Board of County Commissioners
DEPARTMENT OF PUBLIC WORKS
SOLID WASTE MANAGEMENT DIVISION

Re: Citrus County Central Landfill
Permit No. 21375-008-SO/01 and 126602-002-WT/02
Response to Site Inspection Comments received August 25, 2010

Wet Soils removed

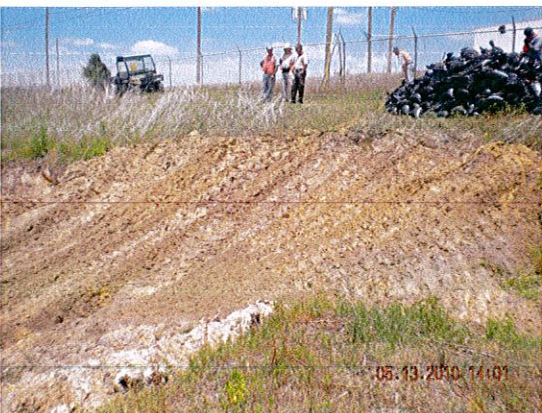
Explanation: Department Staff observed a 10-15 ft. wide surface depression on the South-East back of DRA #4.

Comments: After additional Department (and FGS) investigation, it was determined that the depression may have been caused by slope failure due to erosion. Please provide the Department with current pictures of the area of concern and details on the repair and a schedule for inspection in the future.

Response: The facility determined that the feature in question was the result of run-off collecting in the adjacent swale and moving at too great a velocity thereby causing erosion. Repairs were made immediately following the inspections by the Department and FGS. Unstable wet soils were removed and remaining soils dewatered when overburdened was released, the area was back filled in 12" lifts, hand compacted and brought up to final grade using sand bags. The sand bags were used to maintain a stabilized surface while vegetation re-established itself. Mulch was spread to stabilize the remainder of the disturbed area. Two sand bag dams were installed in the swale to decrease the velocity of the water

in the swale leading to the DRA #4, these proved ineffectual and were replaced by rock check dams constructed of crushed concrete. This process has corrected the erosion noted in the inspection. Staff has been advised to check this during the daily inspections.
